Announcement of Design Number Change for Pneumatic Swing Clamp (model WHC)

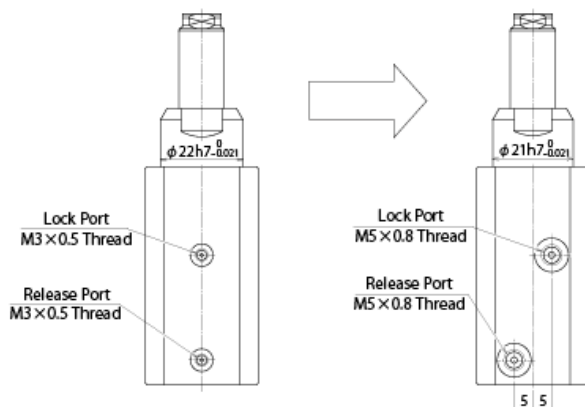
Design number [Model number] has been updated as below for adding long stroke model.

- Anodized aluminum finishing color on cylinder part is changed from red to white.
- Only for WHC0201, there are 2 changes in dimensions.
Port size M3 is changed to M5, and port positions are also changed.
φ22h7 part is changed to φ21h7. (It is interchangeable with existing item.)

- For WHC0321/0401, the change is the color of outside appearance only.
It is interchangeable with existing item.
